AMENDMENT OF SOLICITATION/MODIFICATION OF CONTRACT

(X) 9A. AMENDMENT OF SOLICITATION NUMBER
140L3726R0007

United States Department of the Interior		
Solicitation:	140L3726R0007	
Project:	NIFC CMPS RFIMS Infrastructure Demo	
Title:	**Questions and Answers**

See below secondary transformer nameplate, which is a Photo for #18:

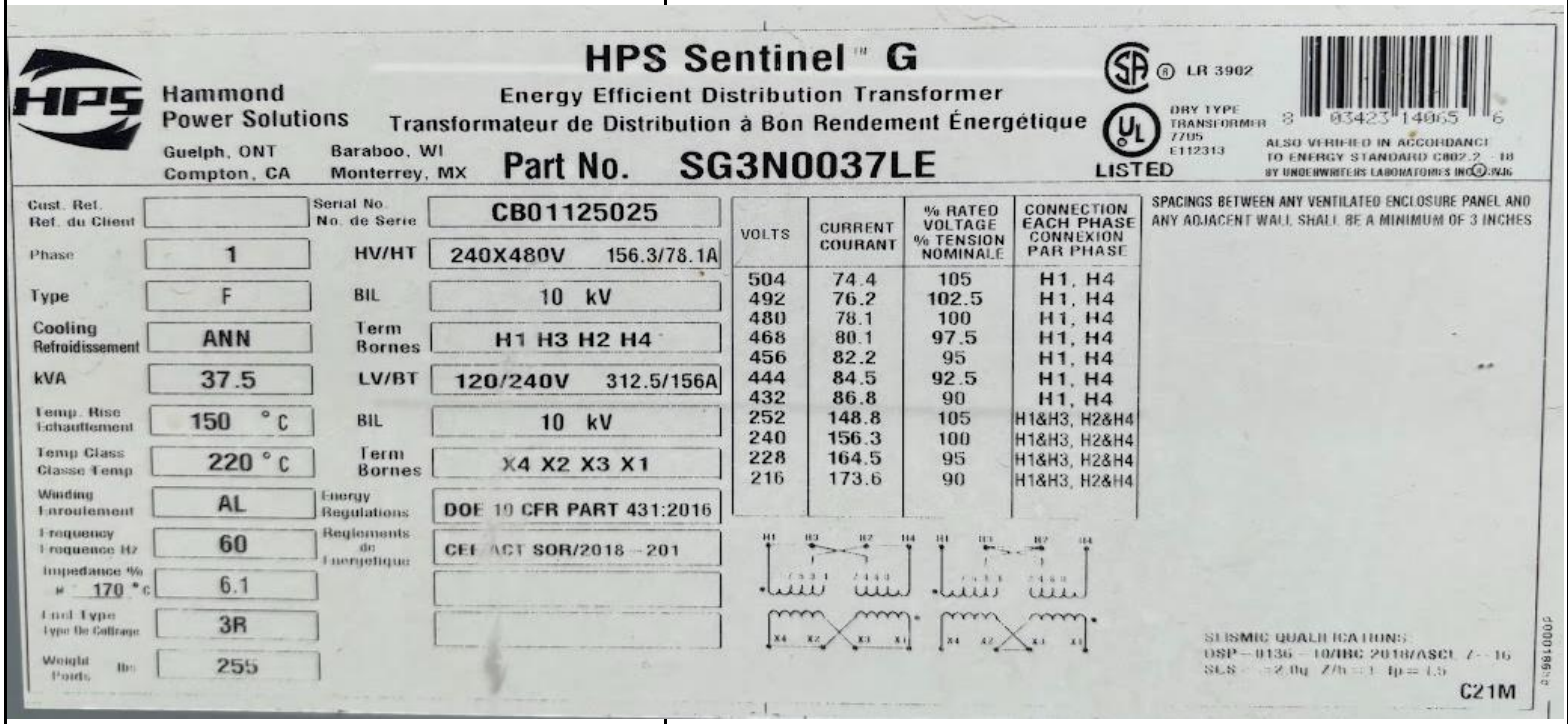
15	Can the Government provide an estimated total linear footage of underground grounding conductor and conduit to be removed?	There is approximately 300 linear feet of grounding conductor to be removed. Conduit can be estimated from Attachment 2.
16	Will Idaho Power disconnect and remove the primary-side electrical connections, or is this the contractor's responsibility?	Per attachment 2 key note 10, contractor to remove the power feed back to primary transformer FC-23. The primary feed to FC-23 and the transformer FC-23 are to remain, as it feeds adjacent building 115-NWS.
17	Who will own the removed transformer and meter equipment? Is salvage retained by the contractor or returned to the Government?	Per attachment 2 key note 9, only the meter is identified to be returned to the government. The secondary transformer shall be removed from the site by the contractor.
18	Are there any known hazardous materials (PCB-containing transformer oil, lead paint, contaminated soil, etc.) associated with the infrastructure?	The transformer nameplate photo is provided below so that the materials associated with that transformer can be determined. No other hazardous materials are known. It is identified as a dry-type transformer. The area of work was constructed in the year 2022.
